SUNDRY NOTICES AND REPORTS ON WELLS

8. Well Name and No.
WH Rhodes B Federal NCT 1 #9

9. API Well No.
30-025-12070

WBD_Rhodes9_PA

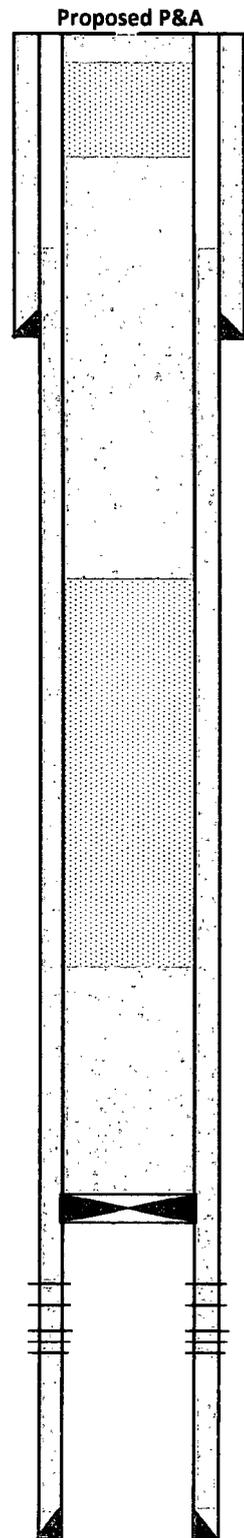
1260. Perf @ 1260. SQZ cement to 1151.
Perf @ 100', SQZ cement surf. WOC Tag
